HARTING Product Change Notification

Business Unit: HARTING Electronics
Product range: D Subminiature IDC range
Author: Thomas Seesing
Title: New D Subminiature IDC - Update

PCN/D-Sub/14/90/ABCD

Date: 2014-10-20

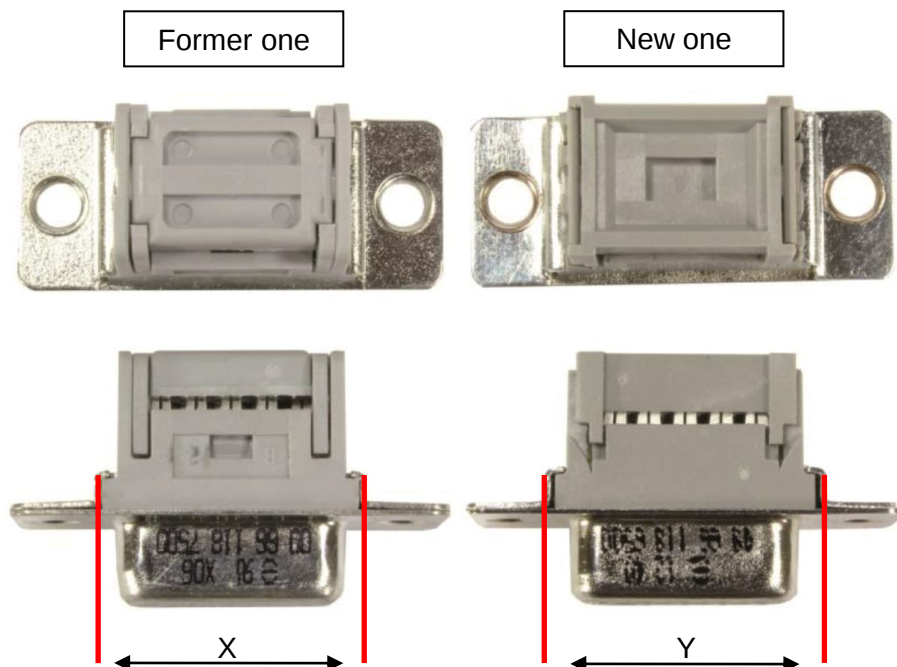
2. Description of changes / news:

With the change to our new Version the width of the insulator changed too.

Size	Polarity	X	Y
1	09	19,2 mm	19,9 mm
2	15	27,7 mm	28,2 mm
3	25	41,2 mm	41,9 mm
4	37	57,8 mm	58,4 mm

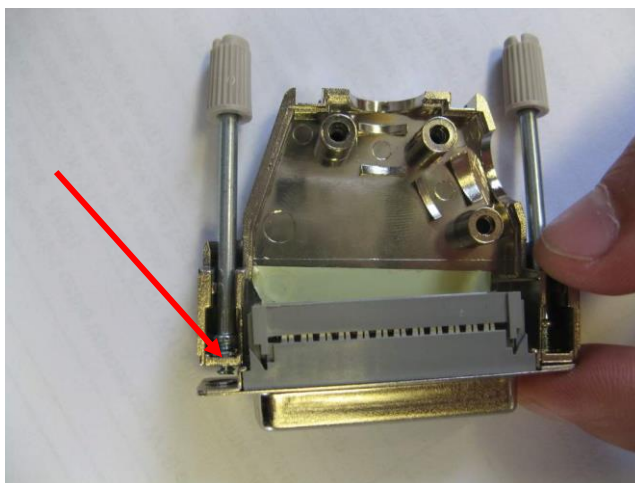
The new Design of our D-Sub IDC connector does not fit in some specific HARTING D-Sub housings.

Fit into Hoods:		Don't fit into hoods:	
Plastic hoods:	Metal hoods:	Plastic hoods:	Metal hoods:
09 67 0xx 0424	09 67 0xx 0343	09 67 0xx 0434	09 67 0xx 0344
09 67 0xx 0426	09 67 0xx 0348	09 67 0xx 0430	09 67 0xx 0349
09 67 0xx 0425	09 67 0xx 0333	09 67 0xx 0435	09 67 0xx 0334
09 67 0xx 0427	09 67 0xx 0336	09 67 0xx 0431	09 67 0xx 0335
09 67 0xx 0571		09 67 0xx 0462	09 67 0xx 0322
09 67 0xx 0573		09 67 0xx 0463	09 67 0xx 0323
09 67 0xx 0442		09 67 0xx 0464	
09 67 0xx 0443		09 67 0xx 0465	
09 67 0xx 0423		09 67 0xx 0411	
09 67 0xx 0422		09 67 0xx 0413	
09 67 0xx 0421		09 67 0xx 0511	
		09 67 0xx 0513

We are now working on this issue to make the design compatible to all HARTING D-Sub housings as soon as possible.
